Glanmire Solar Farm – Request for Information

12th December 2023

Please find our responses to the request for information on the 5th of December from the Independent Planning Commission, in reference to the State significant development application for the Glanmire Solar Farm (SSD 21208499). The request for information follows from the site inspection and community meeting carried out on the 30th of November 2023.

Figure 1 Typical array dimensions

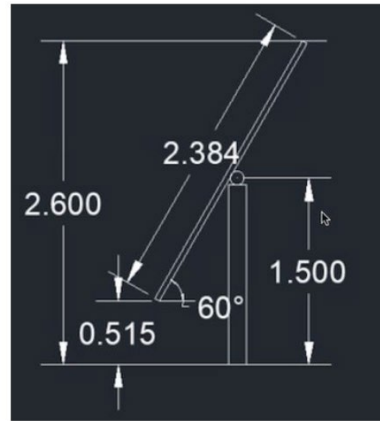
Issue	Reference / Comment	Document Link
Heights		
<p>1. Please confirm the precise height of the proposed solar arrays (at both highest tilt on axis and when horizontal), substation, battery and security fencing.</p>	<p>As final design will occur subject to a competitive tendering process post-approval, most parameters are noted as ‘typical’ or ‘indicative’ at this stage. The maximum height of the arrays is stated, as 3.5m and this was the height used to model the visibility of the Project in the visual assessment. Figure 1 below shows the more typical heights of 2.5–3.0m.</p> <p>To provide more certainty to the community, Elgin are able to accept limits on heights if the IPC imposes these. In this event, the following are the maximum heights that would be appropriate:</p> <ul style="list-style-type: none"> • Maximum height of array when vertical = 3.5m • Maximum height of array when horizontal = Approximately 1.7m (see below plus 20cm panel depth) • Substation = 5.5m with the only taller structures being the lightning arrester poles, which are slimline poles with a maximum height of 15m (refer to Figure 2). • Battery container maximum height = 3.5m • Security fencing maximum height = 2.0m 	<p>Updated Project description, included as Appendix A of the Amendment report, section 1.1</p> <p>Amendment Report</p>

Figure 4 Western boundary – south of the riparian area

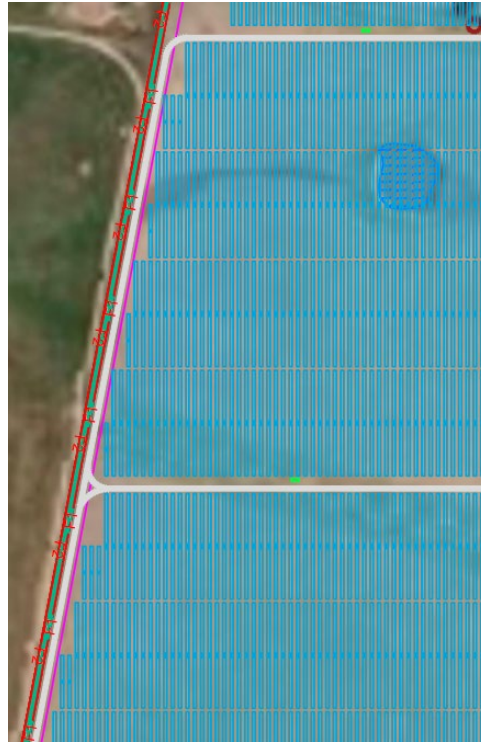
Setbacks & buffers		
<p>2. Please confirm the precise extent of the proposed setbacks on the eastern and western boundaries of the development site, including the extent within these setbacks that is proposed for vegetation screenings, asset protection zones, maintenance tracks, and existing roads.</p>	<p>The setbacks are required by the Project commitments V3 (Landscape Management Plan) and BF3 (bushfire mitigation). These are shown on the Indicative layout as follows:</p> <ul style="list-style-type: none"> Western boundary – north of the riparian area: 10m wide native screening planting required plus 10m APZ required (at the very northern extent, incorporating a 4m wide access track within this) = 20m.  <p><i>Figure 3 Western boundary – north of the riparian area</i></p>	<p>Appendix A – Landscape Concept Plan page 6</p> <p>Amendment Report – A.2 Indicative infrastructure layout</p>

- Western boundary – south of the riparian area: Linear tree planting of 5m plus 10m APZ required (incorporating a 4m wide access track within this) = ~ 15m.

** Note the indicative layout shows the tree planting as 5m but the Landscape plan does not specify a required width. To provide more certainty to the community, Elgin are able to accept a specified setback of 5m, if the IPC choose to impose this.*

Figure 6 Panel exclusion areas

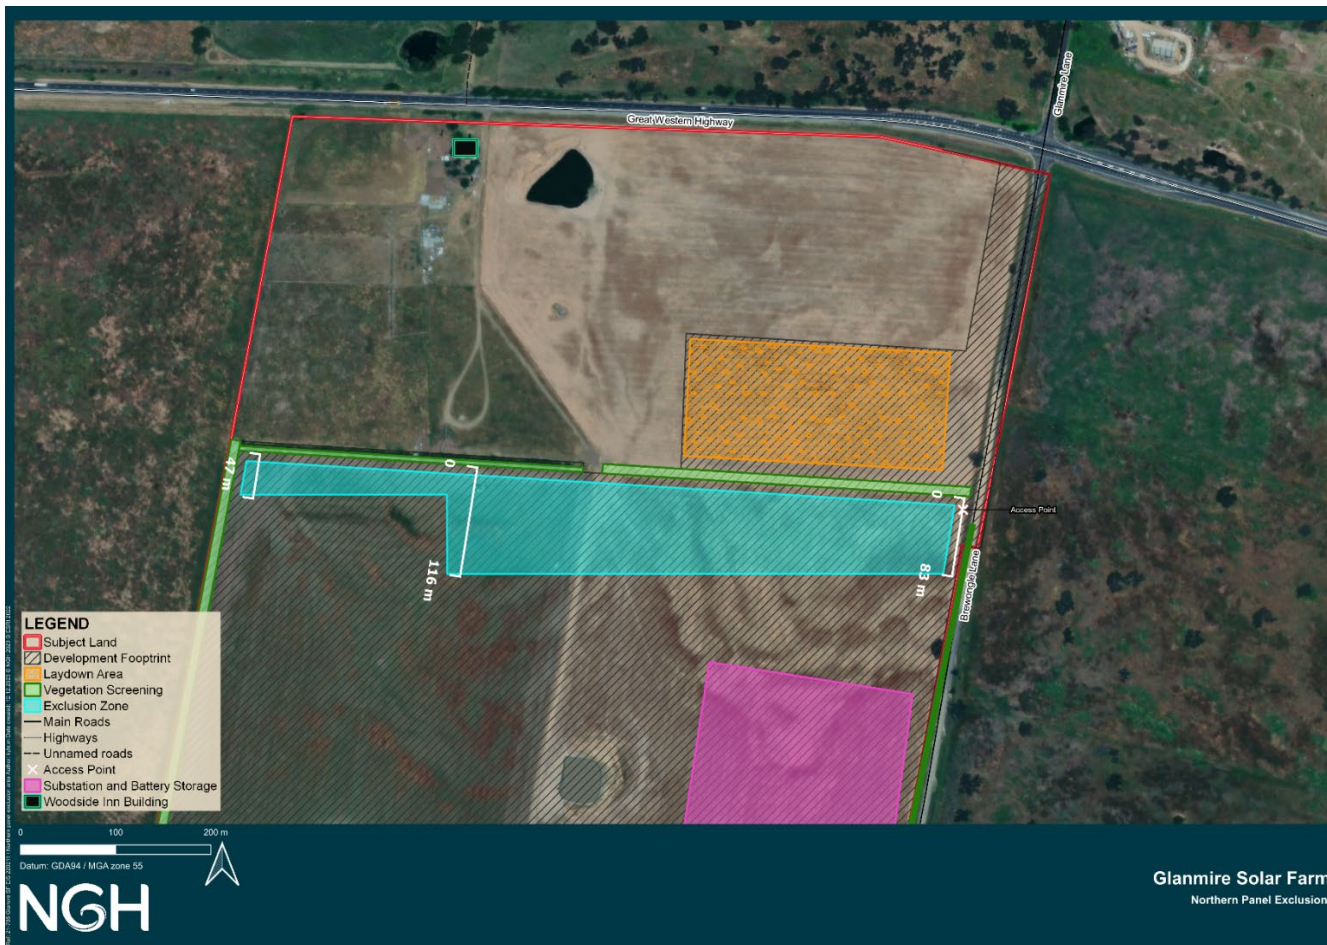
<p>4. Please confirm the rationale for the proposed exclusion zone at the northern end of the site (south of the 300m setback to Great Western Highway).</p>	<p>This additional visual exclusion zone was incorporated into the layout in September 2022 to further reduce glimpse views from the highway. With the addition of this exclusion zone, the highway views on entrance to Bathurst (west bound traffic), including glimpse views, have been eliminated through setbacks and screen planting. The visual viewshed analysis led to these further setbacks to the north of the project.</p> <p>The size of the setback is irregular however the following measurements (measurements are provided to the edge of plantings) are 47m in the west, 116m at its maximum extent and 83m in the east (refer to Figure 6).</p>	<p>Glanmire Solar Farm LVIA report (nsw.gov.au)</p>

Figure 9 Terrain analysis, extracted from Hydrology and Hydraulic Analysis.

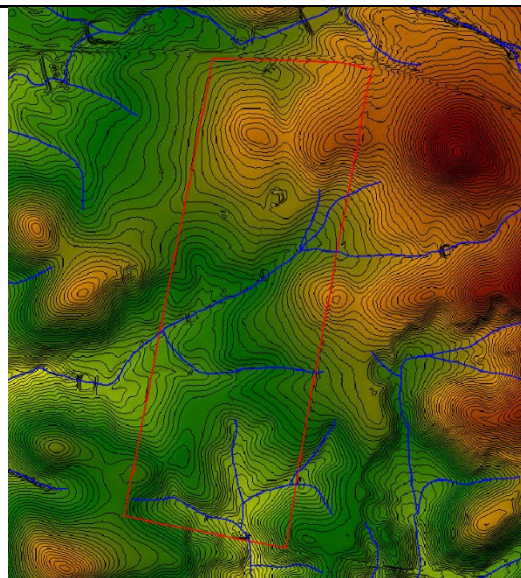
<p>site and whether additional water sources such as dams are required.</p>	<p>but would be monitored and topped up so that it will have a minimum of 20KL of water at all times for fire fighting purposes.</p>	
<p>9. The Commission heard concerns at the Site Inspection, Locality Tour and Public Meeting regarding water storage, flow changes and potential flooding impacts, both on site and to neighbouring properties. Noting this, please advise how the first order stream flowing into R21 and shown in the 'General layout showing Development footprint and constraints' plan (Appendix A.1 of the Amendment Report – see marked up screenshot below) was considered during the Application's design and the final proposed solar PV array layout.</p>	<p>The Hydrological and Hydraulic Analysis assessed the risk of flooding throughout the site. It is completed in two stages (pre and post infrastructure) with the intention of ensuring the infrastructure will be located without significant impacts on offsite water flows or flooding and erosion (by concentrating water flow).</p> <p>The report notes</p> <ul style="list-style-type: none"> • <i>All watercourses within the proposal area would be described as ephemeral and would only contain flowing water during and shortly after rainfall events. There are also 9 small farm dams within the proposal area, mostly located on the existing watercourses.</i> • <i>Except for a small northern portion of the site (approximately 380m) which drains to the north towards the Great Western Highway, the proposal area typically falls from north-east to south and south-west with elevations ranging from about 780m AHD to 735m AHD.</i> <p>The tributary in question is shown in the figure below.</p>	<p>Hydrology Report– Appendix F – Flood Mapping</p> <p>& Mitigation measures W5, W6 and W7 Submissions Report - Appendix B Updated table of mitigation measures</p>

The hydraulic model was re-run with infrastructure to assess the impact on flood behavior for the 1% AEP event (1% Annual Exceedance Probability is used to describe how likely a flood level will be exceeded in any one year). It is noted that the assessment is conservative in that it assumes all dams are full and therefore generate 100% run off in a rainfall event.

Figure 2: Site selection considerations

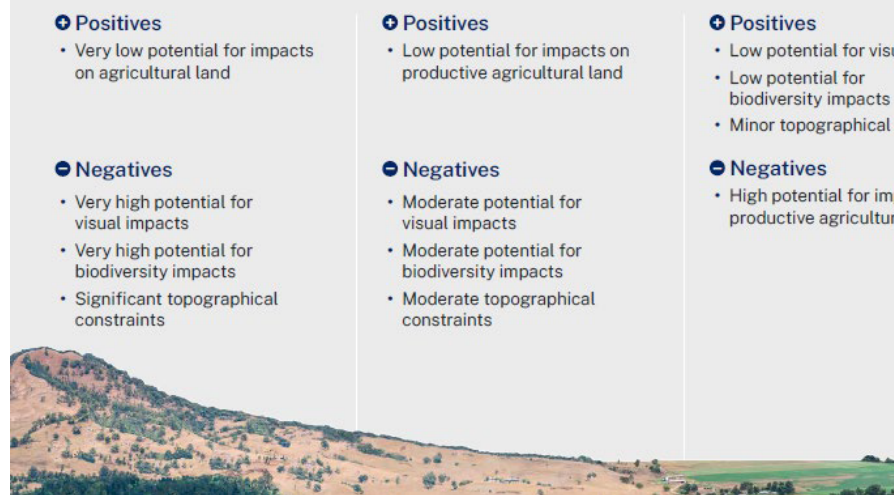
Agricultural Land		
<p>11. The Commission notes that statements were made at the Public Meeting that only 6% of the Bathurst Local Government Area (LGA) comprises cropping land and that the development site is part of that resource. Noting this, please clarify how the Application has been designed to reduce impacts Land and Soil Capability Class 3 land on the site consistent with the Department of Planning and Environment's revised</p>	<p>The Large Scale Solar Energy Guideline (2022) notes that a compromise is required in site selection, where there are competing constraints. The Glanmire Project site typifies the right hand side, where visibility and biodiversity impacts are low but where there can be a some impacts on existing agricultural land.</p>	<p>Submissions Report Appendix F Updated Soil and Agricultural Assessment page 22, section 3.1.2, Section 2.4.1 and Section 5.3.1</p>

1. Applicants should consider the agricultural capability of the land during the site selection process.
2. Applicants should avoid siting solar energy projects on important agricultural land as far as possible.
3. Agricultural assessment should be proportionate to the quality of the land and the likely impacts of a project.
4. Mitigation strategies should be adopted to ensure that any significant impacts on agricultural land are minimised.

These principles have been applied. Soil surveys of increasing intensity have been undertaken from early in the project development. An agricultural impact statement has been prepared to evaluate the impact. Mitigation centers on restoring land capability for all areas with the exception of the substation. As such the impacts are considered highly reversable with regard to agricultural
